METROPOLITAN GOVERNMENT OF NASHVILLE AND DAVIDSON COUNTY

STAFF RECOMMENDATION
3725 Central Avenue
October 19, 2016

Application: New construction-outbuilding; Setback determination
District: Richland-West End Neighborhood Conservation Zoning Overlay
Council District: 24
Map and Parcel Number: 10409004800
Applicant: Tucker Tingle, Allard Ward Architects
Project Lead: Paul Hoffman, paul.hoffman@nashville.gov

1 Site Plan

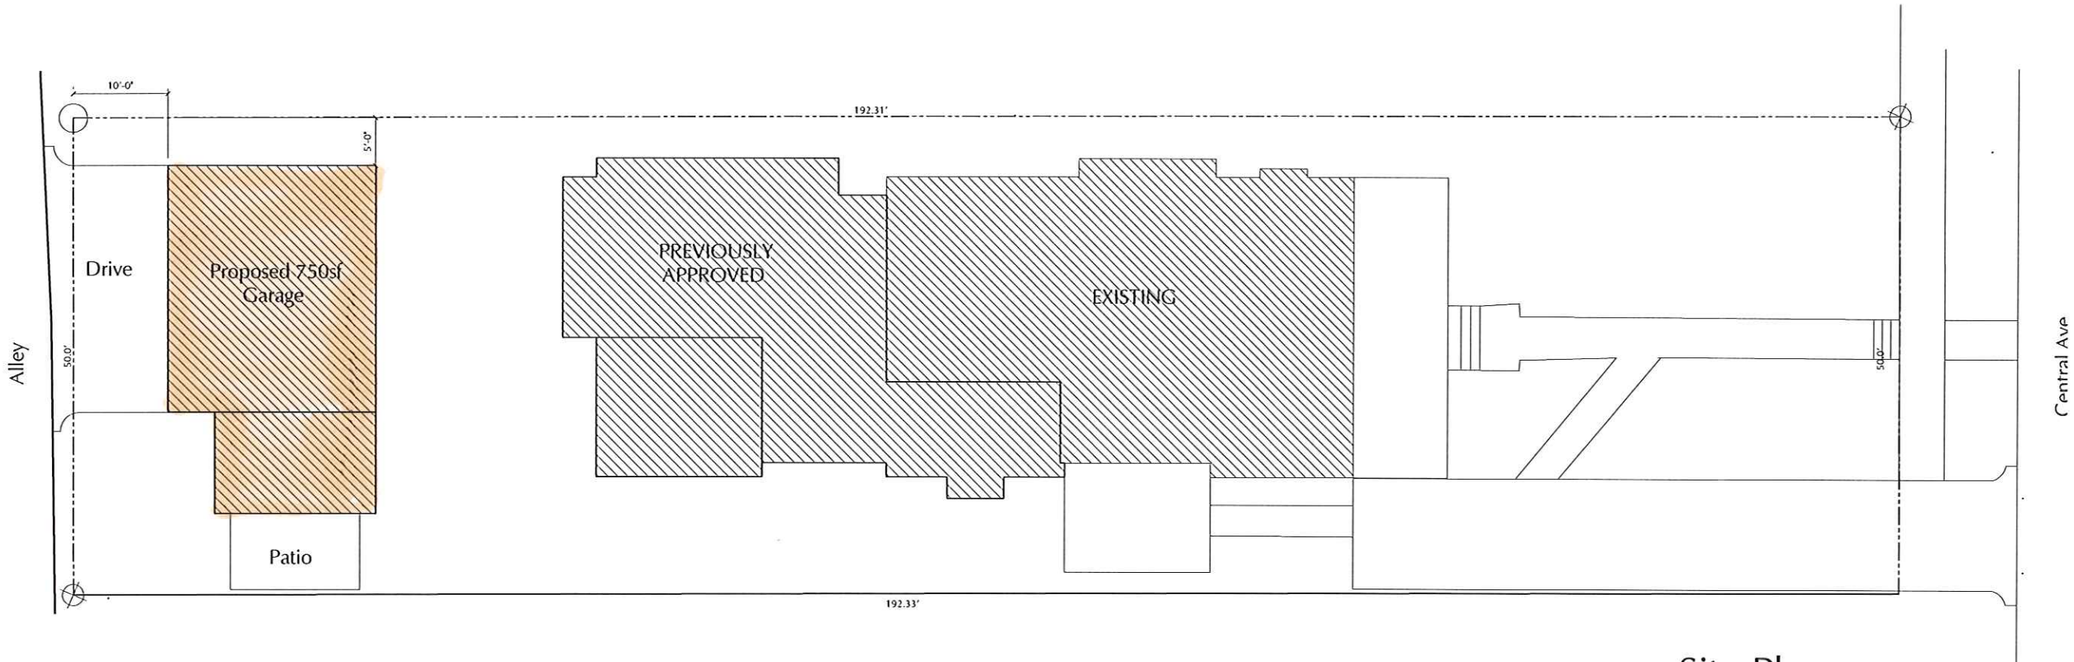
MINIMUM	PROPOSED
Space between principal building and DADU/Garage	20'	19'
Rear setback	20'	10'
L side setback	5'	8'
R side setback	5'	5'
How is the building accessed?	From the alley or existing curb cut	Alley access

The outbuilding is one foot less from the principle building than the Commission typically approves; however, since the difference is so minimal, Staff finds nineteen feet between the outbuilding and rear of the home to be appropriate.

The applicant requests a setback determination for the rear setback. The outbuilding's footprint is seven hundred and fifty square feet (750 sq. ft.) When an outbuilding has a footprint greater than seven hundred square feet (700 sq. ft.), base zoning requires that the structure be located twenty feet (20') from the rear property line and five feet (5') from the side property lines. In this instance, the structure is located at least five feet (5') from the side property lines, but it is located ten feet (10') from the rear property line. Staff finds that the proposed rear setback is appropriate because a ten foot (10') setback is the standard rear setback for structures that are seven hundred square feet (700 sq. ft.) or less. Also, historically, outbuildings were located at the rear of the property, close to the rear property line. A ten foot (10') rear setback is more historically appropriate than a twenty foot (20') rear setback. In addition, the ten foot (10') rear setback allows for more space between the primary structure and the outbuilding. Staff recommends approval of the setback determination.

The project includes a patio that. because it has no cover, was not included in the calculations. The project meets Section II.B.1.h.2 of the design guidelines.

1 First Floor Plan-750sqft

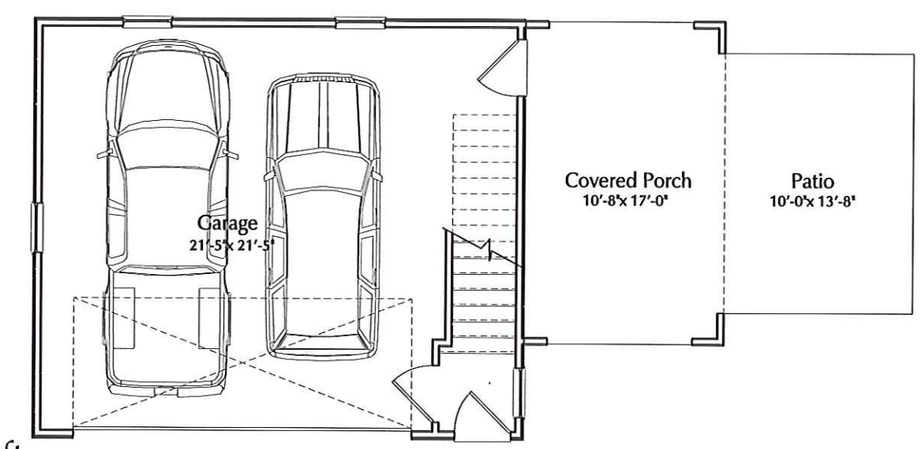
Lot is less than 10,000 square feet	**~~Lot is more than 10,000 square feet~~**	**50% of first floor area of principle structure**	**Proposed footprint**
Maximum Square Footage	750 sq. ft.	~~1,000 sq. ft.~~	1,000	750
